Subject: Supplemental Information Regarding Seismic Hazard and Screening Report (Central and Eastern United States (CEUS) Sites) - Response to NRC Request for Information Pursuant to 10 CFR 50.54(f) Regarding Recommendation 2.1 of the Near-Term Task Force Review of Insights from the Fukushima Dai-ichi Accident

The purpose of this letter is to provide supplemental information to address the NRC staff technical questions and issues resulting from the NRC's preliminary review of the seismic hazard re-evaluation reports provided for Clinton Power Station, Unit 1, Limerick Generating Station, Units 1 and 2, Oyster Creek Nuclear Generating Station, and Quad Cities Nuclear Power Station, Units 1 and 2, as discussed at the June 17, 2014 EGC/NRC meeting. This information provides additional detailed basis and justification for the inputs and parameters used in the EGC seismic hazard re-evaluation reports supporting the EGC determination that these plant sites meet the requirements of the NRC endorsed SPID criteria (References 7 and 8) and therefore screen out from further seismic risk assessment, as discussed at the June 17, 2014 EGC/NRC meeting.

Supplemental Information in Response to NR

Figure 14

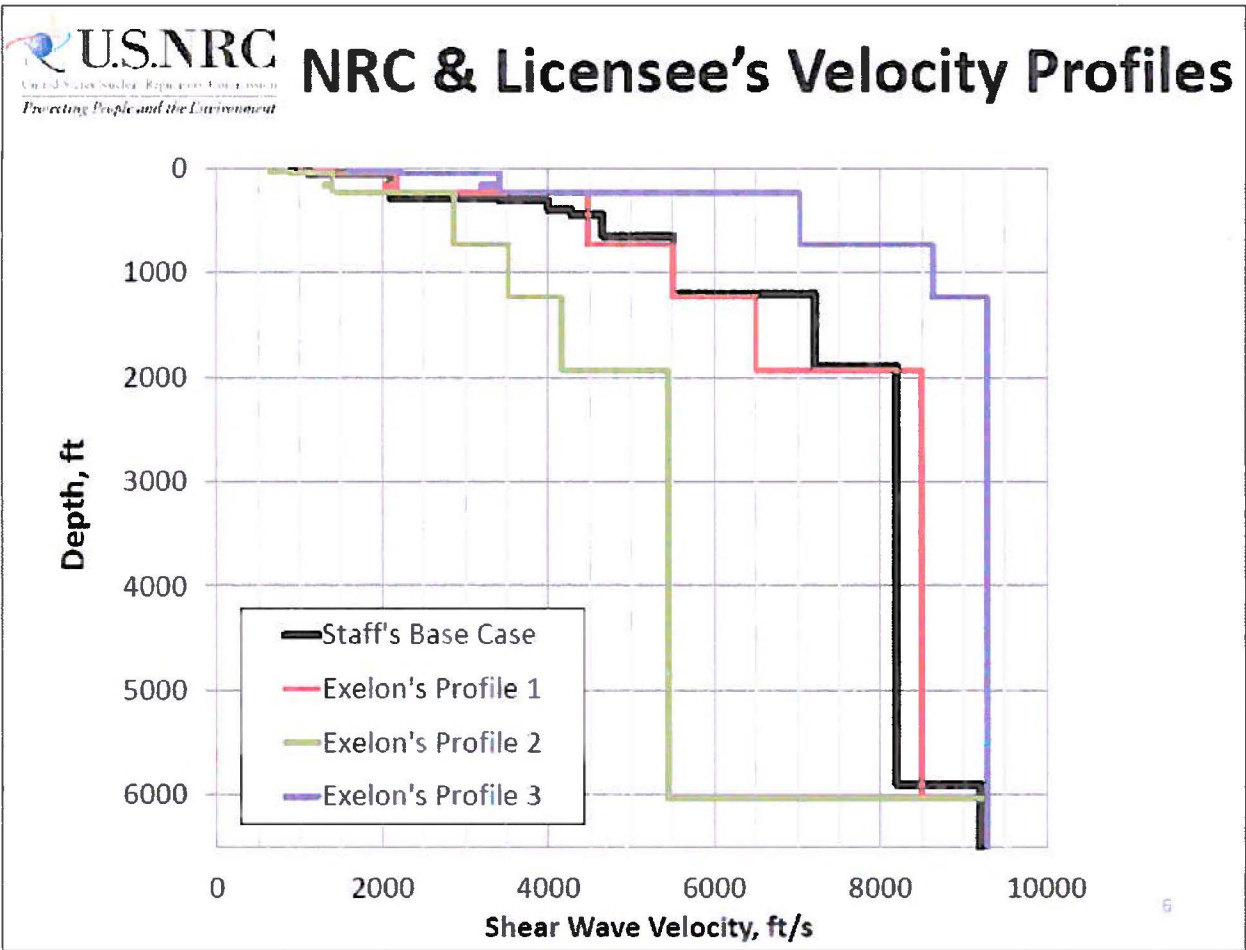
Based on the methodologies used and data considered to develop the base-case soil profile, there are differences between the NRC soil profile and the Exelon soil profile (noted as P1 in Ref. 3). A plot of the soil profiles was presented in the NRC public meeting presentation (Ref. 9), and is shown in Figure 14.

The Exelon base-case soil profile stratigraphic layer thicknesses are based on the soil boring under the CPS containment building. The ranges of layer thicknesses for data at the ESP and CPS site were reported to show variability across the site. Exelon contends that ranges of data should be included to develop the base-case profile so that uncertainty is adequately considered in the re-evaluation.

Figure 17

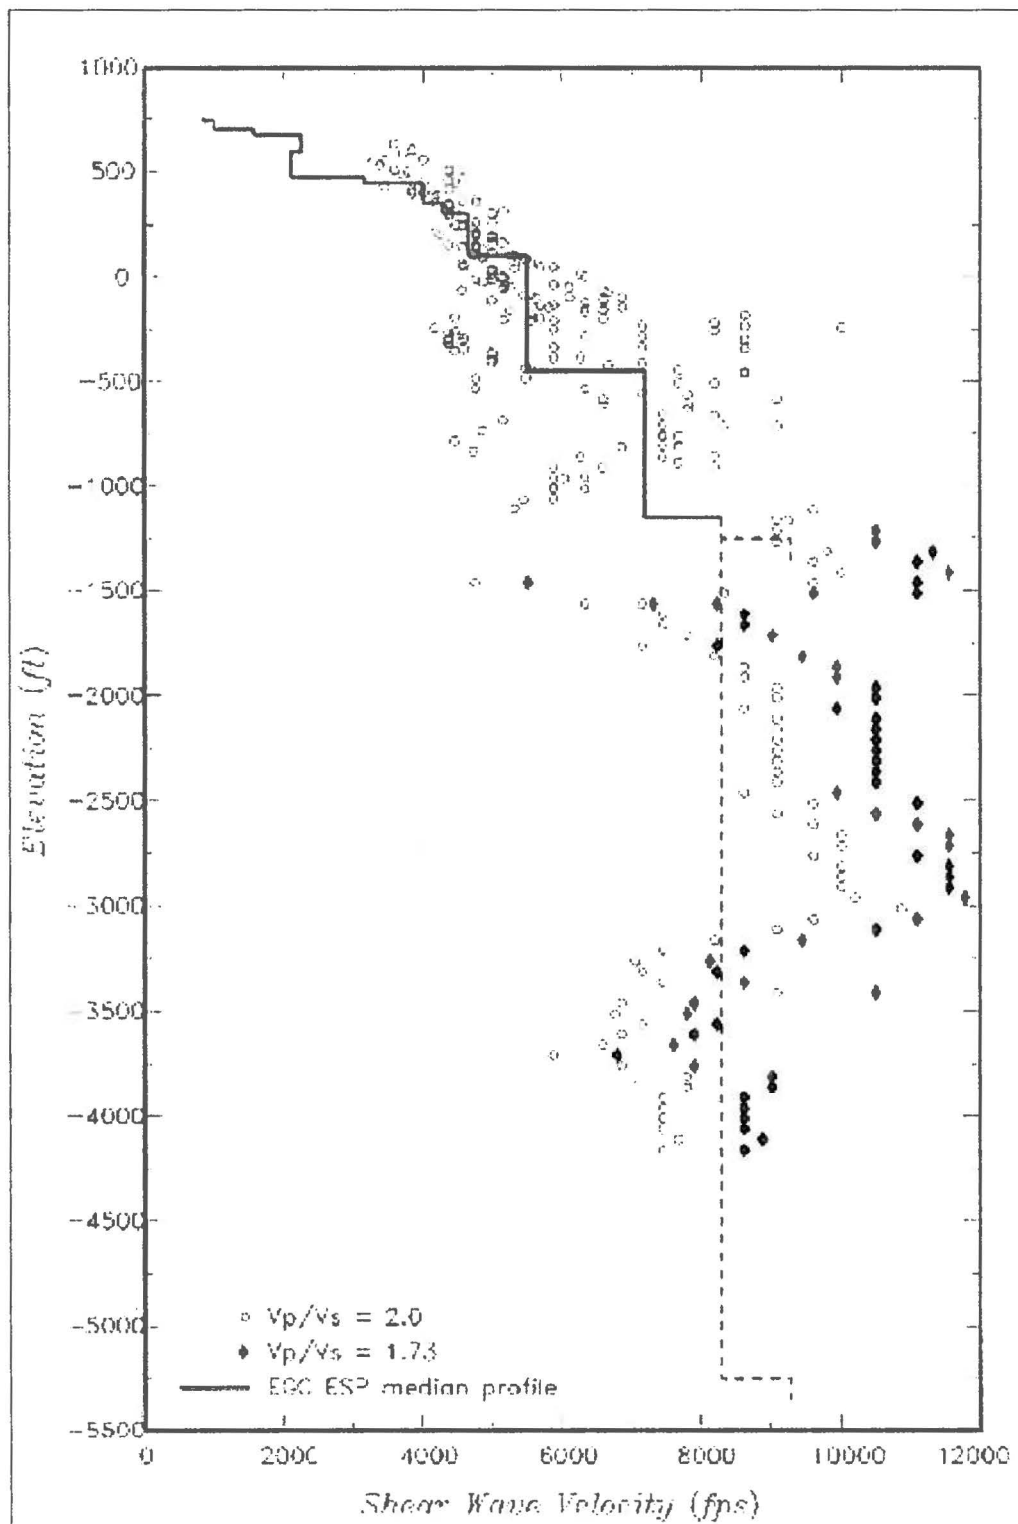
Below 1,898 ft, the NRC best estimate V_s is approximately 8,200 fps, which appears to have been obtained from the lower-bound dashed curve in Figure 17. This lower-bound curve was computed for the ESP using an estimated Poisson's ratio of 0.33, whereas the upper-bound dashed profile was computed using a Poisson's ratio of 0.25. At these depths, the ESP analysis accounted for uncertainty in V_s by randomizing profiles with a uniform distribution between the upper-bound and lower-bound profiles shown in Figure 17. By using the lower-bound profile from Figure 17 as their best estimate, the NRC has effectively biased the profile toward the lower end of the V_s range estimated in the ESP.

Figure 18

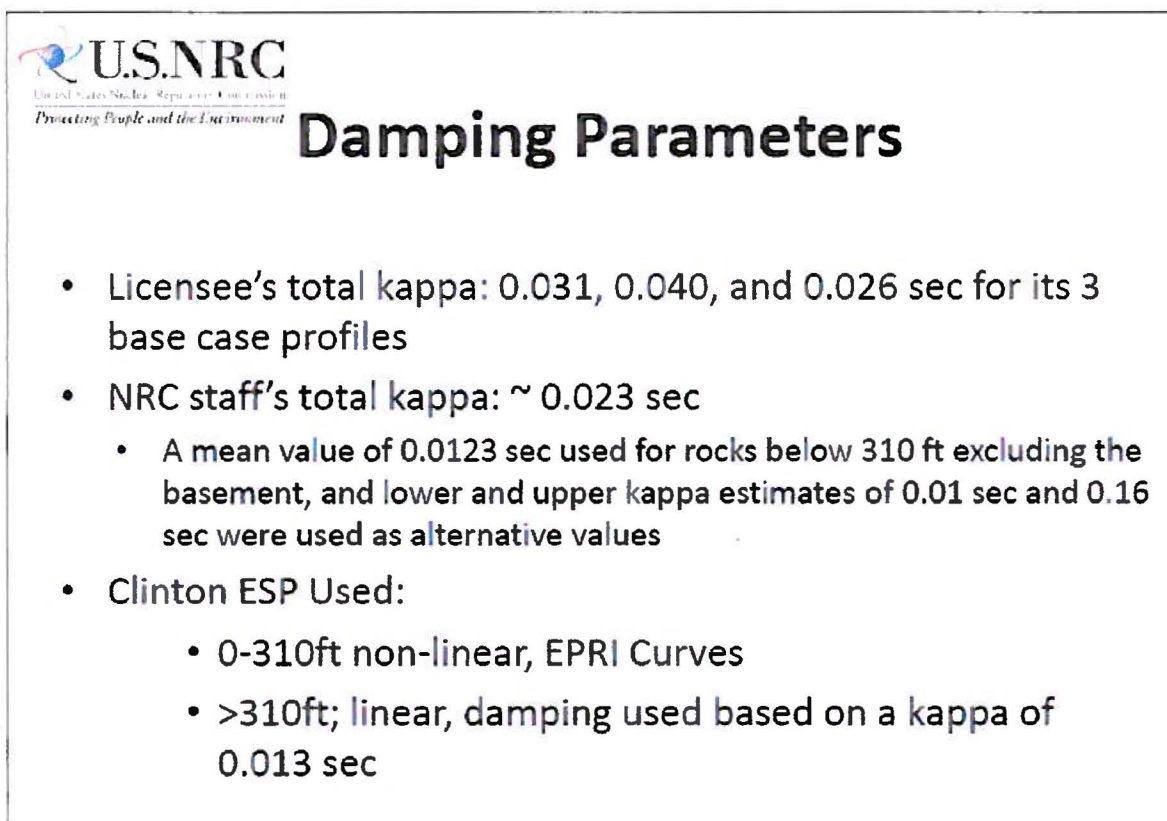
The NRC considered a Total Effective Kappa of approximately $K = 0.023$ s (Ref. 9) as shown in Figures 18. The NRC also presented their consideration of damping and Kappa values as shown in Figure 2.

Based on the NRC slides in Figure 2 and Figure 18 above, Exelon understands that the NRC considered multiple cases for the Kappa contribution from firm rock. The NRC considered that there was "No Damping" contribution for the firm rock layers. It appears that there was a base-case profile with firm rock Kappa contribution of $K = 0.0123$ s, plus a lower-bound profile with firm rock Kappa of $K = 0.01$ s, and an upper bound profile with firm rock Kappa of $K = 0.016$ s. However, it is unclear how the lower-bound and upper-bound values were determined. Exelon understands that the NRC used the base-case firm rock Kappa, $K = 0.0123$ s, to calculate Total Effective Kappa.

Figure 19

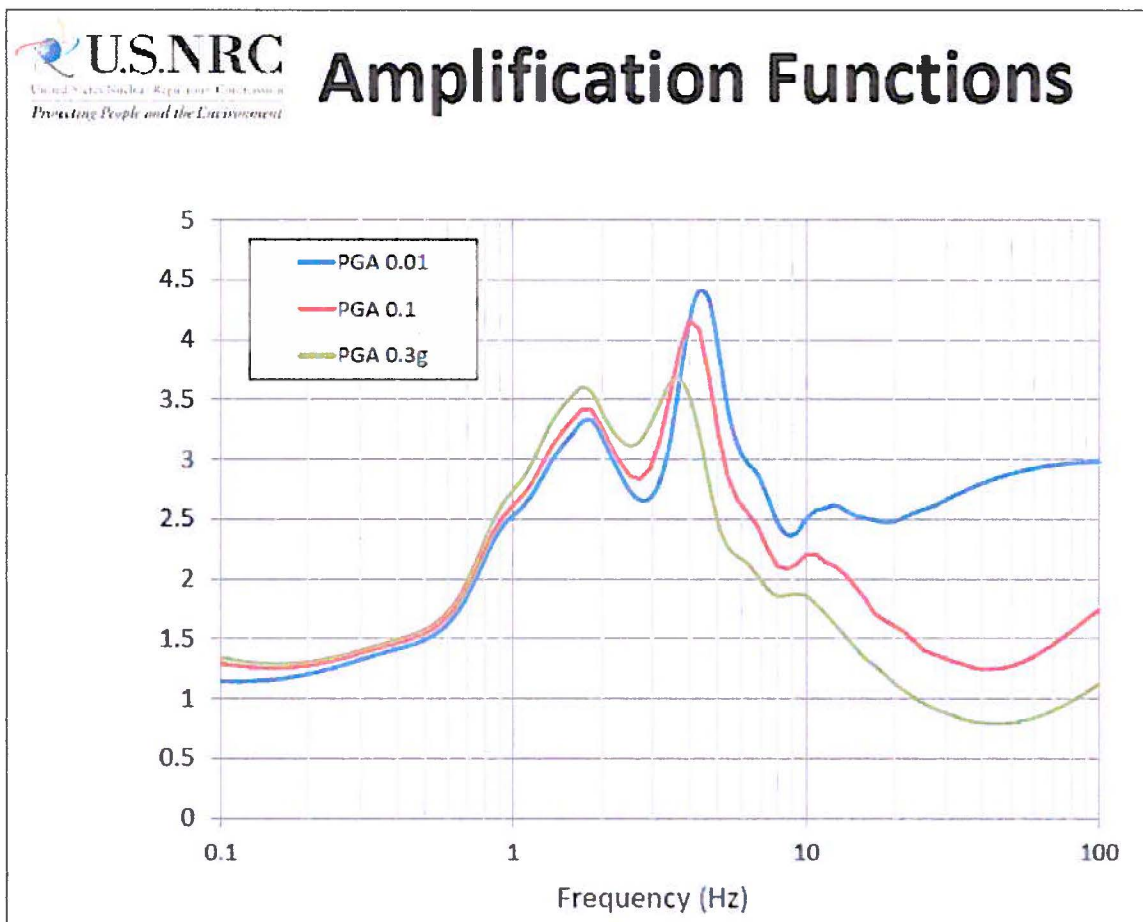
The NRC provided a plot of amplification functions in their presentation (Ref. 9). The plot is shown in Figure 19 below.

The NRC has not provided sufficient detail on the methods they used to develop the amplification functions. Therefore, Exelon cannot develop an understanding of the NRC amplification functions methodology.

The results of the site response analysis are derived from amplification factors which describe the amplification (or deamplification) of hard reference rock motions as a function of frequency and input reference rock amplitude. The amplification factors are represented in terms of a median amplification value and an associated standard deviation for each oscillator frequency and input rock amplitude. A minimum median amplification value of 0.5 was used in the analysis in accordance with the SPID (Ref. 1, Section B-5.1.4.1). Eleven loading levels were parametrized by the median hard rock peak acceleration (0.01g to 1.50g) for each profile and EPRI soil and firm rock G/G_{\max} and hysteretic damping curves.

Figure 1: Limerick GMRS Differences between Exelon and NRC [Ref. 8]

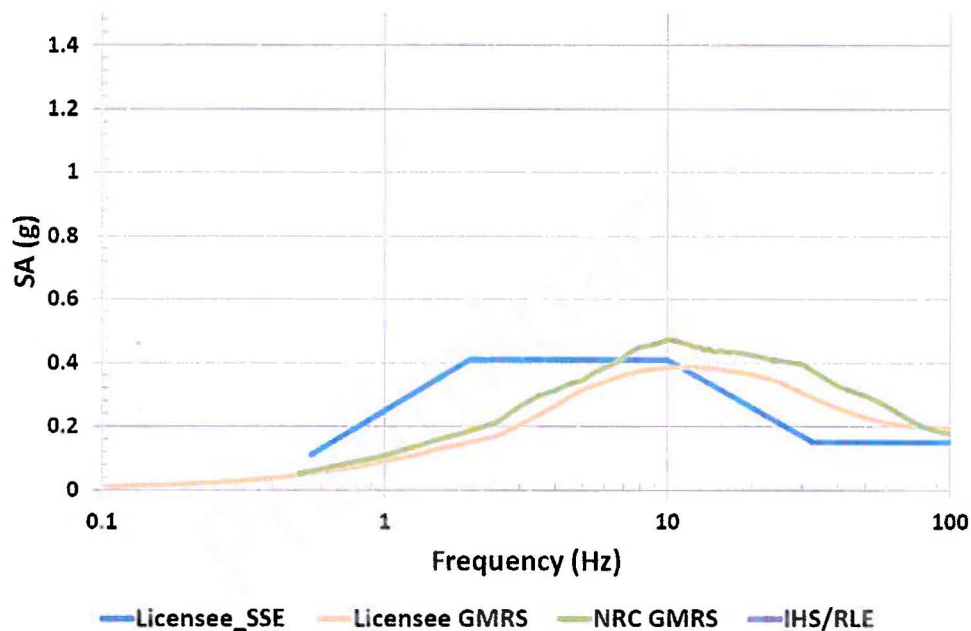
The GMRS independently developed by Exelon and NRC are shown together in Figure 1 below, as presented by the NRC [Ref. 8]. It is important to note that, despite the acknowledged technical differences of certain underlying inputs, the GMRS from both Exelon and NRC are rather similar.

Figure 2: Comparison of Limerick Shear-Wave Velocity Profiles Developed by NRC and EPRI [Ref. 8]

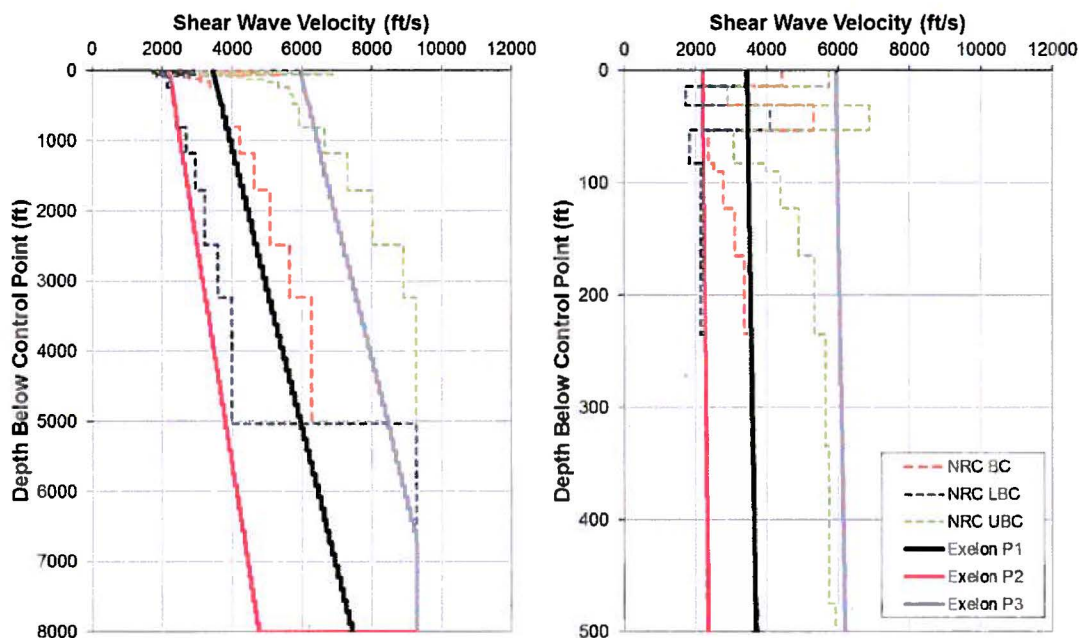
The Exelon and NRC shear-wave velocity profiles are based on similar interpretation of largely the same data. Graphs illustrating both the Exelon and NRC profiles presented by the NRC during the June 17 public meeting [Ref. 8] are repeated below as Figure 2. Although qualitatively similar, visible differences between Exelon and NRC shear-wave velocity profiles include the granularity of the near-surface data applied, the shape of the extrapolated profile from the near-surface to bedrock, and the depth to bedrock. The NRC shear wave velocity is slightly lower at the shallower depth (<500ft) and greater at the deeper layers than Exelon.

The near-surface data applied by the NRC includes a somewhat significant jump in shear-wave velocity data, which would be expected to result in potential resonances at high-frequency, perhaps accompanied by increased amplification compared to the shear-wave velocity profile applied by Exelon. Based on the varying geologic and geotechnical data available at the Limerick site from both original plant licensing as well as ISFSI implementation [Ref. 13], it is unclear whether such a geologic structure is representative of the complete Limerick site and therefore applicable to the GMRS calculation discussed herein.

relatively inconsequential to the ultimate GMRS calculation given the general similarity of the profiles and specific site characteristics. Staff and consultants from both NRC and Exelon appeared to be in agreement regarding this judgment.

For purposes of NTTF 2.1: Seismic screening, additional study to evaluate the specific impact of these differences on GMRS amplitude would be warranted only if the GMRS incorporating resolution of kappa is very close to the plant SSE spectra.

Figure 1

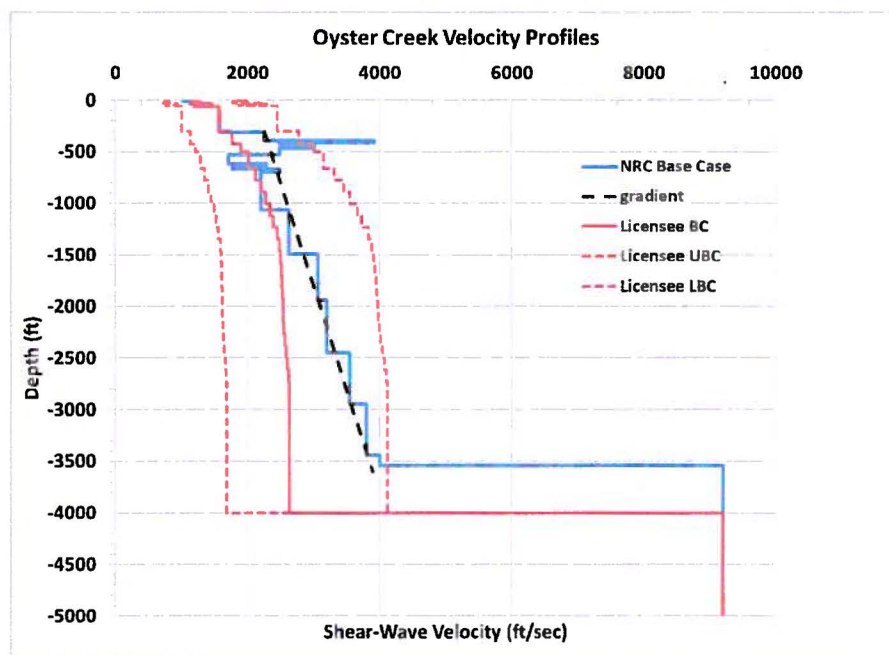
A slide from the June 17 public meeting with the NRC is shown in Figure 1. This slide (from Reference 31) presents the NRC base case and the best case, upper bound and lower bound shear-wave velocity profiles used by Exelon on the same graph. The graph also shows the gradient for firm rock sites as defined in Section B-3.1 and shown in Figure B-6 of the SPID (Reference 1). The differences in shear-wave velocity profile between NRC and Exelon can be described for three distinct depth ranges: shallow near-surface (top 350 feet), intermediate depth (between 350 feet and approximately 1200 feet below the surface), and deep layers (between approximately 1200 feet below the surface and basement bedrock).

In the shallow-near-surface depth range, the NRC and Exelon shear-wave velocity profiles are nearly identical, with the exception being related to the control point elevation (see separate discussion on control point in Item 4). This implies that site-specific data has been interpreted equivalently by both NRC and Exelon for soil in the top 350 feet below the surface.

Figure 8

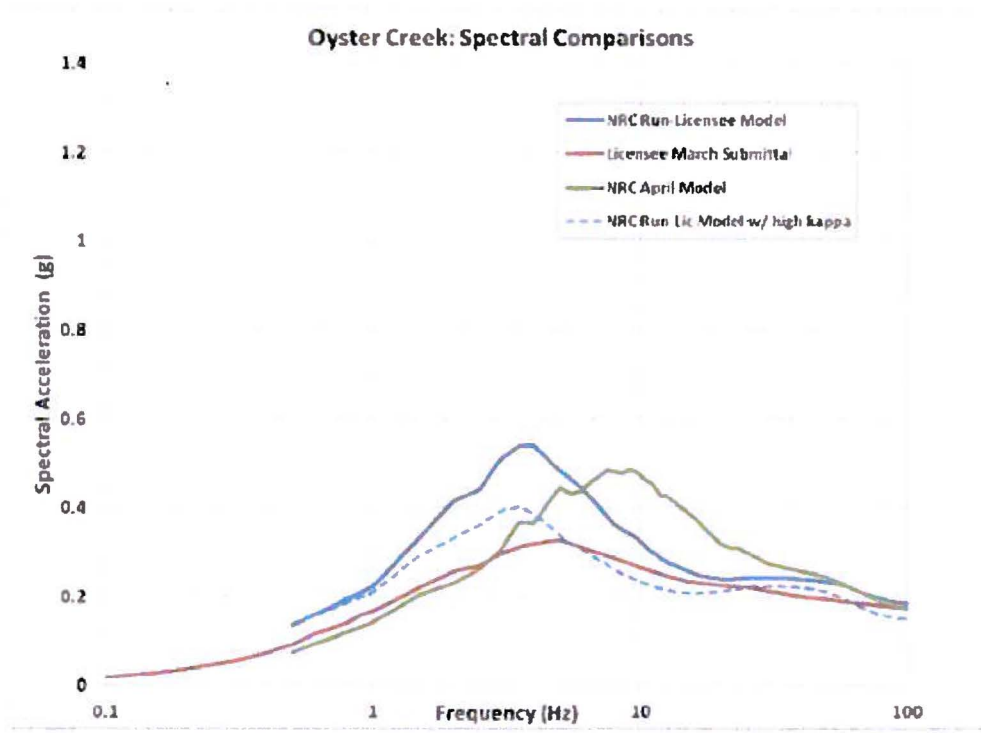
At the NRC public meeting held on June 17, 2014, the NRC presented a comparison between the GMRS generated by Exelon and the GMRS generated independently by the NRC. The GMRS generated by Exelon were provided to the NRC in Exelon's submittal on March 31, 2014 (Reference 3). The GMRS generated by the NRC were issued in their memo of May 21, 2014 (Reference 29). As noted during the meeting on June 17, there are differences between the GMRS generated by the NRC and the GMRS generated by Exelon. As discussed previously, differences in estimations of kappa and differences in soil velocity profiles directly led to differences in the GMRS. However, as shown in the NRC slides (Reference 31), the GMRS generated by the NRC are different from the ones generated by Exelon even when the NRC used the inputs reported to have been used by Exelon. During the meeting on June 17, the NRC presented GMRS that had been generated using the same inputs as those reported to have been used by Exelon. This slide demonstrates that the NRC was not able to duplicate the GMRS provided by Exelon in the March 31 submittal (Reference 3) even using the same inputs as those used by EPRI. The relevant NRC slide is shown in Figure 8.

From Figure 8, it is apparent that the GMRS generated by Exelon (red) and the GMRS generated by the NRC (dashed blue) are characteristically different in shape as well as amplitude. As part of the discussion of the differences in the GMRS generated by the NRC and the GMRS generated by Exelon, the NRC also presented comparisons of the amplification functions developed by Exelon and those developed by the NRC using the inputs reported to have been used by Exelon. The comparisons of amplification functions are provided in the NRC slides from the public meeting of June 17, 2014 (Reference 31) and in Figures 9 and 10.
